# Technical Service Information

## ZF-4HP-22/24

### REPEATED LEAK FROM BELL HOUSING AREA

Figure 1

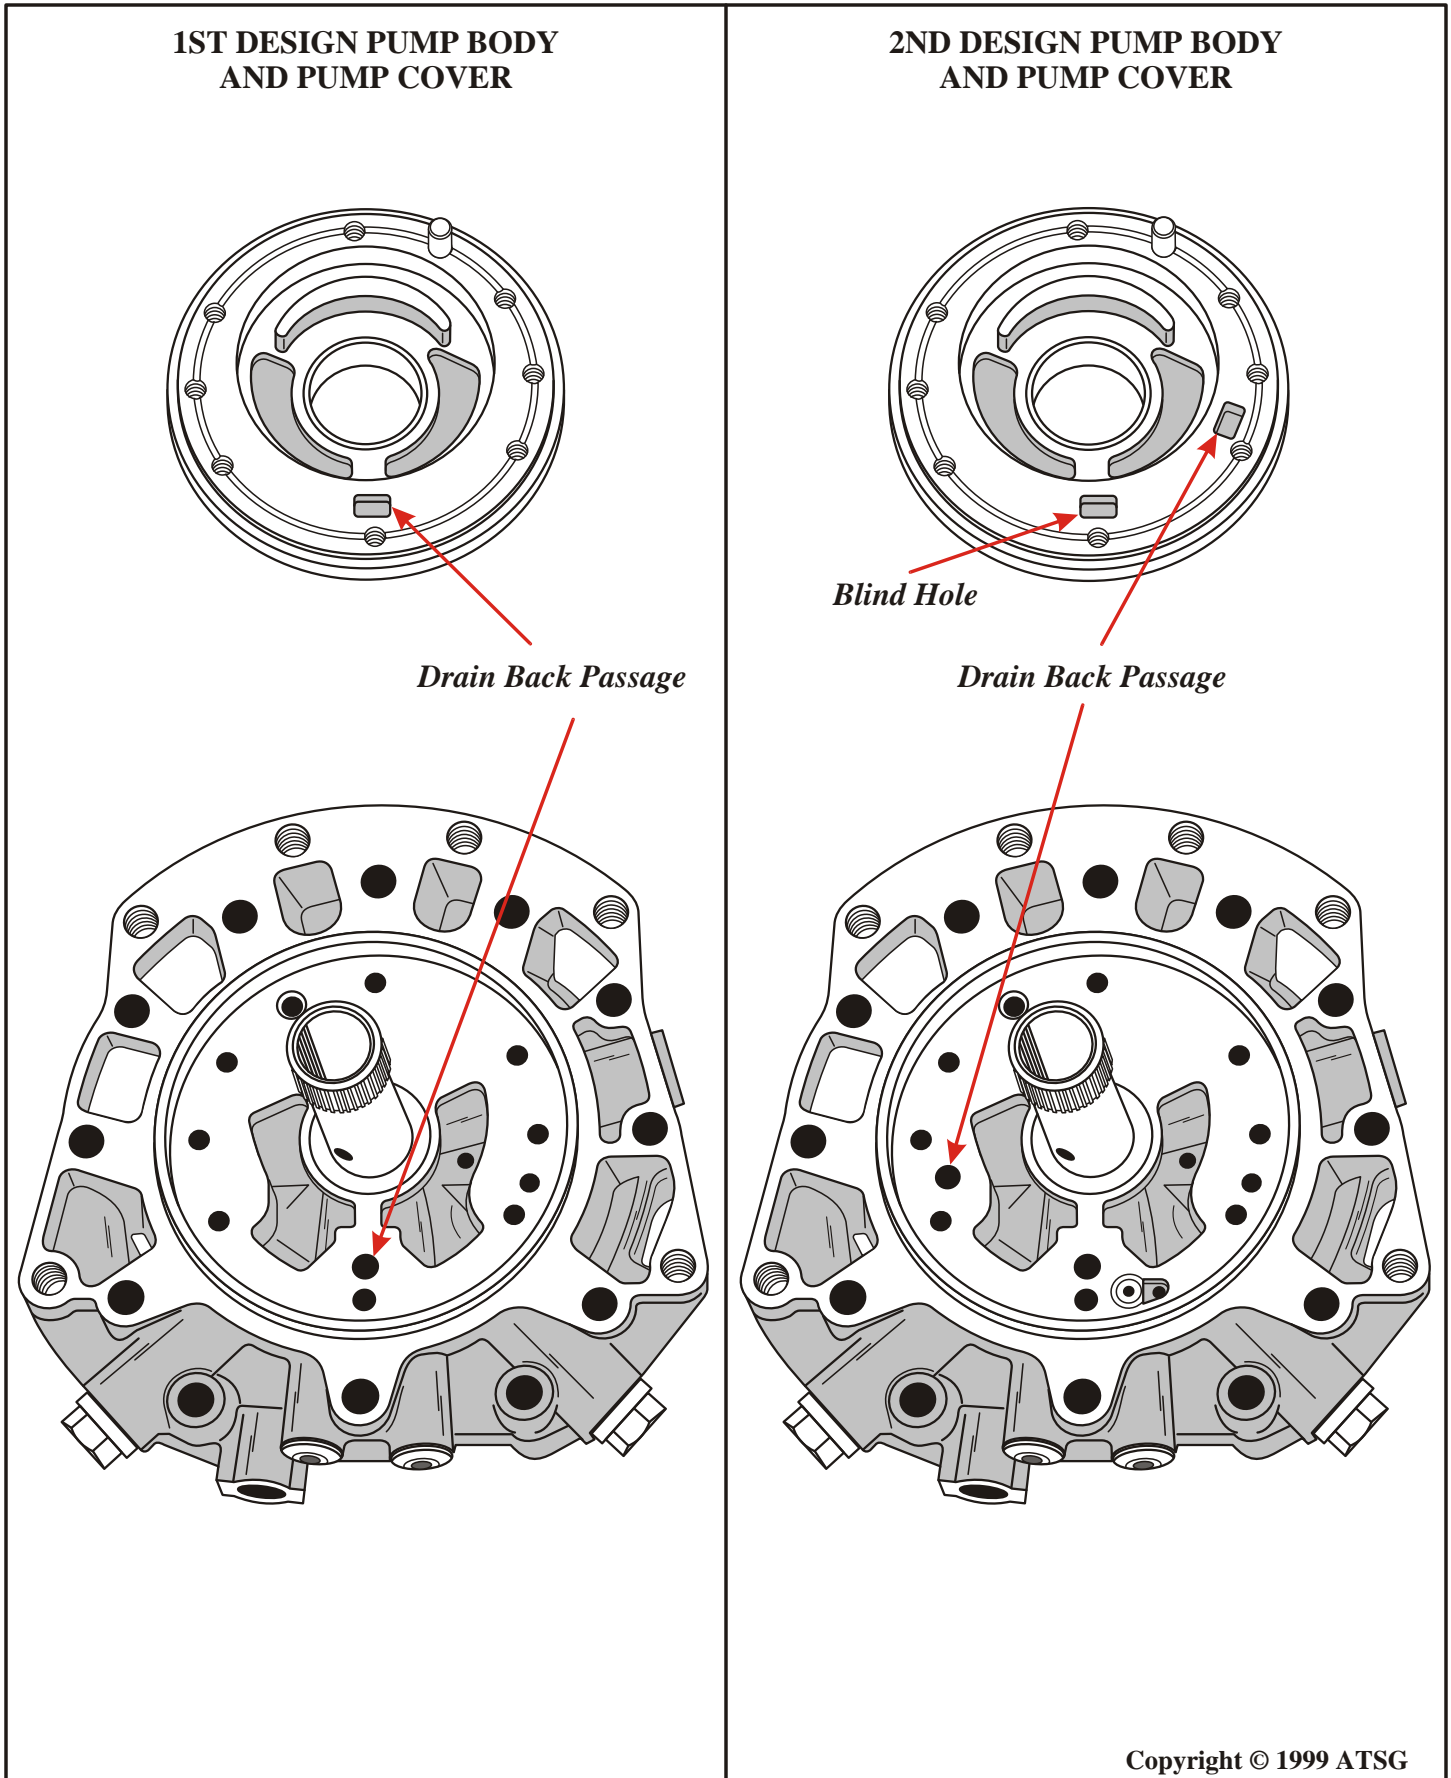
- COMPLAINT:** Repeated leakage of transmission fluid, coming from the bell housing area on any vehicle equipped with the ZF-4HP-22 or 4HP-24 transmission. This usually occurs after rebuild coupled with pump parts replacement that was necessary.

- CAUSE:** Beginning in the 1989 model year, ZF implemented a running change to the pump body and pump cover on both the 4HP-22 and the 4HP-24 transmissions. This change was made to increase the durability of the converter bushing with increased lubrication to this area. This change however, created the possibility of mis-matching parts that are not compatible. The 1st design pump body and cover has the drain back hole located at the 6 O'clock position and the drain back passage was moved to the 3 O'clock position in the 2nd design pump body and cover, as shown in Figure 1. Installing 2nd design pump body with 1st design pump cover will completely block the drain back passage and the repeated leakage will occur. Installing the 1st design pump body with 2nd design pump cover will function, but you will now be faced with the possibility of premature converter bushing failure.

- CORRECTION:** To eliminate both conditions, always install the 2nd design pump body, matched with the 2nd design pump cover, as shown in Figure 1.
